DART AEROSPACE LTD	Work Order: 89875
Description: Crosstube Assembly (205/212/412 High Fwd)	Part Number: D212-664-141
Inspection Dwg: D212-664-141 Rev: D	Page 1 of 2

DRAWING NO. D212-664-141	TITLE XTUBE ASSY (205/212/412 HI FWD)	REV. D	DART AEROSPACE LTD ENGINEERING ORDER		D.E.O. NO. D212-664-141-D-1	SHEET NO. SHEET 1 OF 2	SCALE NTS
DRAWN	CHECKED	OP	MFG. APPR.	RE	APPROVED	MP	DE APPR.
DATE 11.04.07	DATE 11.07.11		DATE 11.04.12		DATE 11/09/12		DATE 11.04.12

DRAWING NO. D212-664-141	TITLE CROSSTUBE ASS'Y (205 HI FWD)	REV. D	DART AEROSPACE LTD ENGINEERING ORDER		D.E.O. NO. D212-664-141-D-2	SHEET NO. SHEET 1 OF 1	SCALE NTS
DRAWN <i>UP</i>	CHECKED <i>ASS</i>	MFG. APPR. <i>AB</i>	APPROVED <i>MD</i>		DE APPR. <i>HH</i>		
DATE 11.07.15	DATE 11.07.20	DATE 11.07.21	DATE 11/07/21		DATE 11.07.21

DRAWING NO. D212-664-141	TITLE XTUBE ASSY (205/212/412 HI FWD)	REV. D	DART AEROSPACE LTD ENGINEERING ORDER		D.E.O. NO. D212-664-141-D-3	SHEET NO. SHEET 1 OF 1	SCALE NTS
DRAWN AJS	CHECKED 92	MFG. APPR. 140	APPROVED 140		DE APPR. 140		
DATE 12.06.28	DATE 12.07.05	DATE 12.07.05	DATE 12.07.05		DATE 12.07.05

**D212-664-141/-141B
ASSEMBLY DETAIL**

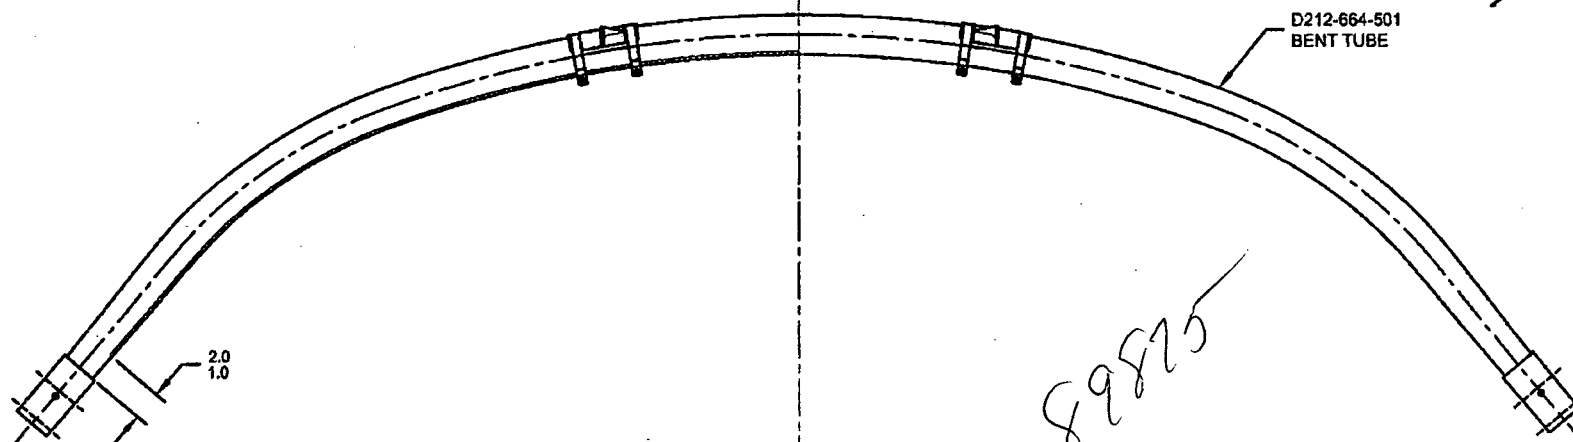
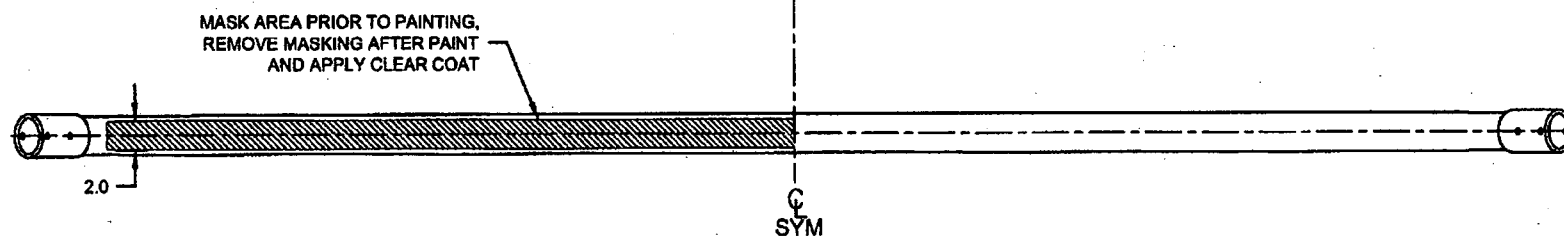
PURPOSE:

ADD AN INSPECTION WINDOW TO UNDERSIDE OF CROSSTUBE.

CHANGE:

NOTES 2 OF SHEET 1 IS AMENDED AS FOLLOWS:

- 2) FINISH: CHEMICAL CONVERSION COAT PER DART QSI 005 4.1
PRIME INSIDE AND OUTSIDE PER DART QSI 005 4.2
MASK UNDERSIDE OF CROSSTUBE AS SHOWN (HATCHED AREA) AND
PAINT OUTSIDE PER DART QSI 005 4.2
REMOVE MASKING AND APPLY CLEAR COAT
